CALIFORNIA COASTAL COMMISSION

STAFF REPORT: REGULAR CALENDAR

APPLICATION NO.: 4-98-024

PROJECT DESCRIPTION: Follow-up to Emergency Coastal Development Permit No. 4-98-024-G for placement of rock rip-rap revetment along an approximately 500 foot long section of the west bank of lower Malibu Creek. The proposed project also includes revegetation of the revetment site to create approximately 0.59 acres of riparian and upland habitat.

Exhibit 6
4-98-024 (Mariposa)
Surveyed Site Plan with Cross Sections

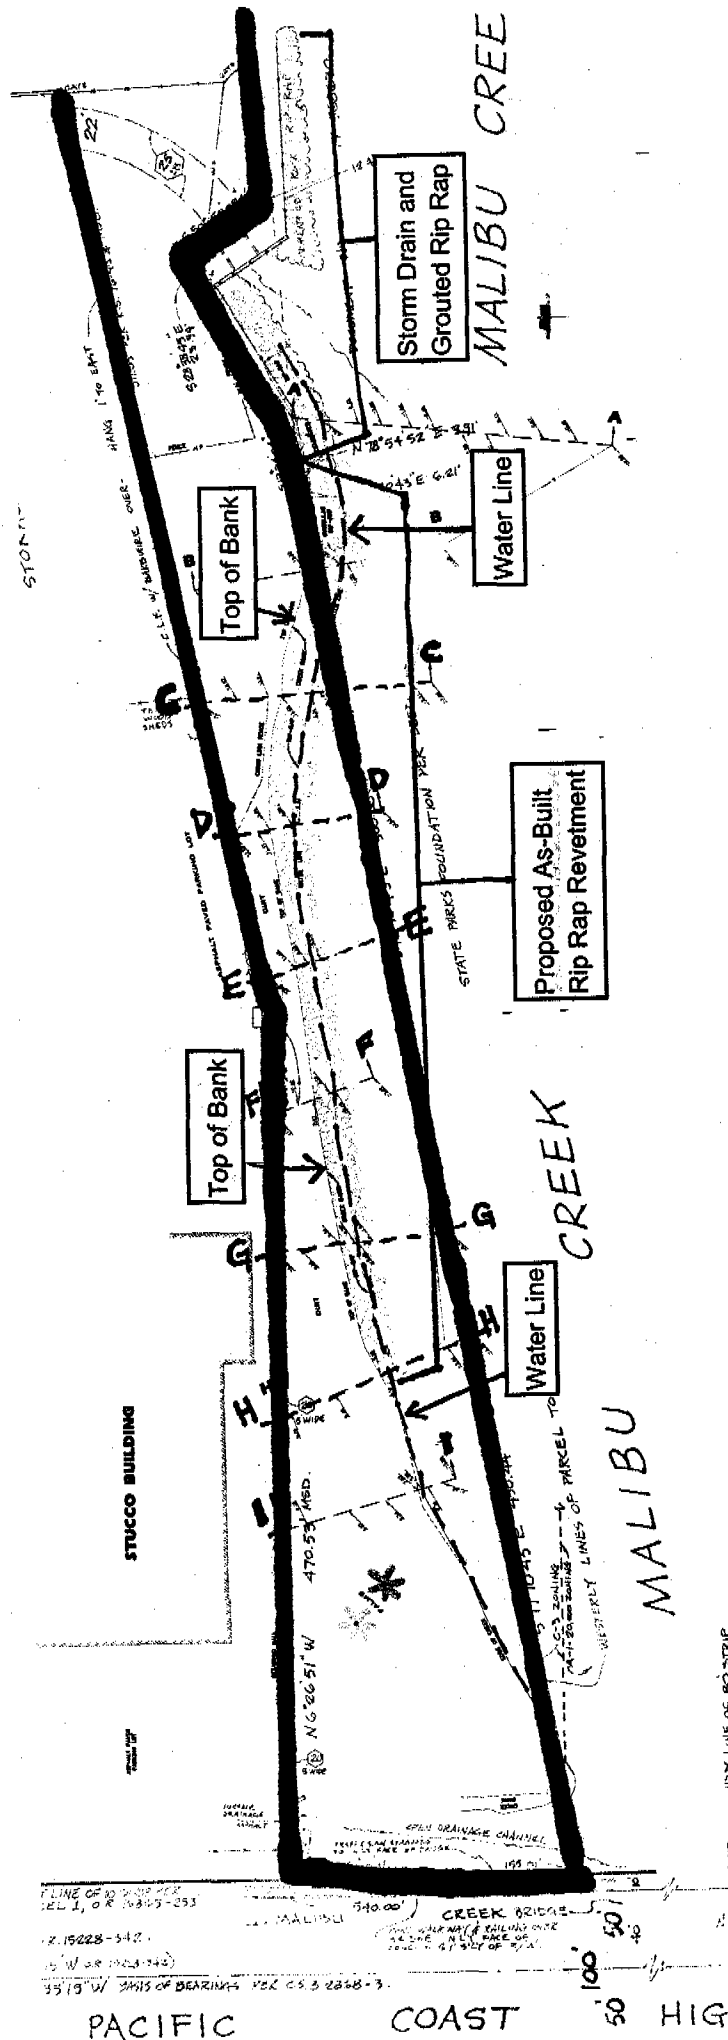
Analysis of Proposed Project: The applicant is requesting permanent authorization for an un-engineered, as-built rip rap revetment, consisting of 1,500 tons of 0.5 to 8-ton granite boulders placed at approximately 1:1 to 1.5:1 (H:V) slope and 14-16 feet in height (2-4 foot toe below stream bed). Since the revetment site is almost completely devoid of native riparian vegetation, the applicant is also proposing to revegetate the revetment site to create approximately 0.59 acres of riparian and upland habitat. To vegetate the existing rock revetment, the applicant had, until recently, proposed to secure fascines of willow cuttings to the rip rap with wire. These willow bundles would be oriented at a 45-degree angle, facing downstream, with one end placed into the creek. Once the willow fascines produced sufficient roots, the interstitial spaces would be filled with sand and fine gravel as a substrate for additional plantings. The applicant also proposes to plant the upland area above the revetment with a mixture of native shrubs and trees, such as mulefat, sycamore, black walnut, cottonwood, and elderberry. In a letter dated January 9, 2009, Impact Sciences Inc. revised the proposed “Vegetation Restoration Plan” to omit the willow fascine element and to instead place willow cuttings that are at least one inch in diameter and six feet long into the interstitial spaces between rocks. Once the willows establish, the interstitial spaces would be filled with sand and fine gravel as a substrate for additional plantings. In researching examples where the concept of securing willow fascines to rock had been used successfully per the request of Commission staff, Impact Sciences found that willow fascines were not appropriate for use atop a rock slope protection and that the willows needed contact with moist soil beneath the rock. After consulting with the Natural Resources Conservation Service, Impact Sciences revised their revegetation plan to instead place willow cuttings into the spaces of the as-built rip rap.

The as-built stabilization is quite steep, approaching 1:1 in some locations. The applicant's engineer asserts that the steepness of the bank stabilization is intended to mimic the natural bank cut that developed on the outer bank of the creek bend. However, this steepness does not readily allow for plants to colonize in the voids between the rocks and, from inspection of photographs of the stabilized bank it appears that most of the bank is void of vegetation.

1. That the rock slope protection has been re-engineered to be laid back to a maximum 2:1 (H:V) slope. However, the toe of the slope protection shall not extend further into the creek than currently exists. If determined feasible, the footing portion of the rock slope protection may remain in place and only the upper portion of the rock shall be laid back to a maximum 2:1 slope.
2. That geotextile filter fabric and live willow stakes are incorporated into the re-engineered rock slope protection during construction, consistent with the Revised Revegetation Plan required as part of **Special Condition No. 3** below.

at all. The applicant would need to prepare a revised engineering design for the new revetment. Also management plans would be needed to control silt and turbidity and schedule the revetment rebuilding to minimize impacts to coastal resources. Based on all information provided by the applicant, it appears feasible that this slope can be rebuilt at a more gradual 2:1 slope.

Planting Plan

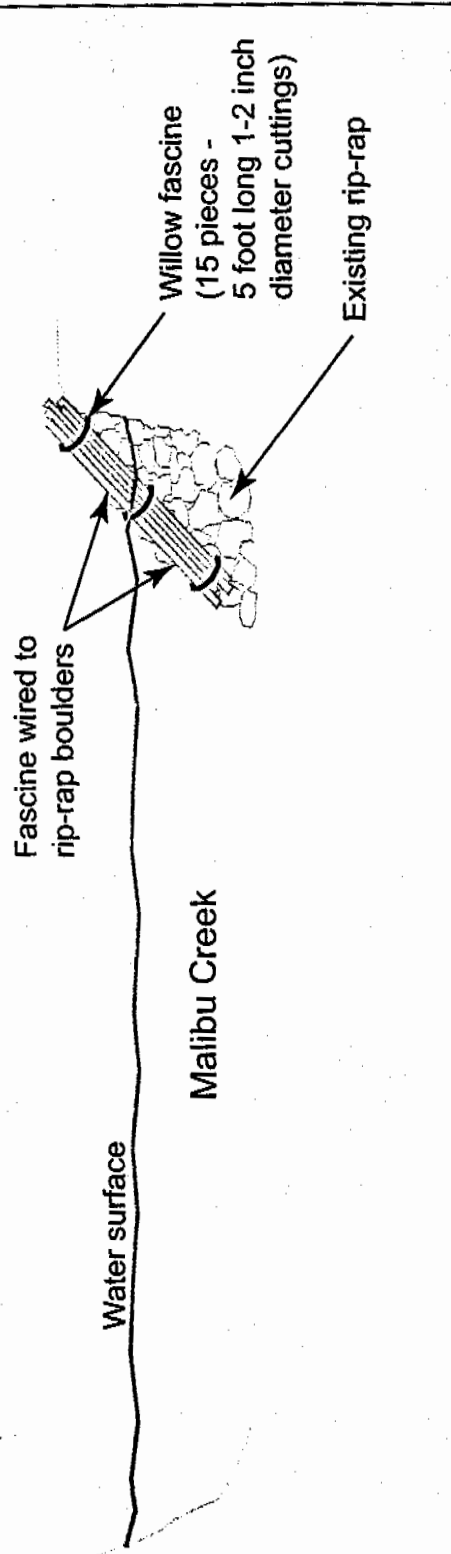
Impact Sciences proposes to modify one aspect of the "Vegetation Restoration Plan - Malibu Creek", the restoration plan that was submitted as part of the application package for Malibu Land Company's pending final permit for bank stabilization along Malibu Creek. Specifically, Impact Sciences now proposes to use willow cuttings, rather than using the willow fascines fastened to the riprap.

Therefore, we propose to modify the plan by eliminating the willow fascines, replacing them with willow cuttings, placed into the interstitial spaces between

riprap, and into the soil where the soils is sufficiently moist on a permanent basis. Willow cuttings, which shall be at least one inch in diameter and six feet long, shall be planted at an average of one cutting per eight linear feet (63 - 65 cuttings), with some areas planted more closely than other areas to give a more natural appearance. The exact location of each willow cutting shall be determined by the project biologist.

1. The "Vegetation Restoration Plan" (by Impact Sciences Inc., dated 8/2007 and amended 1/2009) shall be revised pursuant to the approved rock slope protection plan required by **Special Condition 2** above. The revised plan shall indicate that geotextile filter fabric with holes for willow plantings will be placed on the graded slope of the bank prior to rock placement to stabilize the soil. As the rock revetment is being installed, live willow stakes shall be inserted among the voids, making sure the stakes penetrate the fabric filter and underlying soil. Interstitial spaces in the rip rap shall be partially filled with a fine gravel, sand, and soil combination. In addition, mugwort (*Artemisia douglasiana*) and yerba mansa (*Anemopsis californica*) shall be added to the plant palatte for revegetation of the revetment.
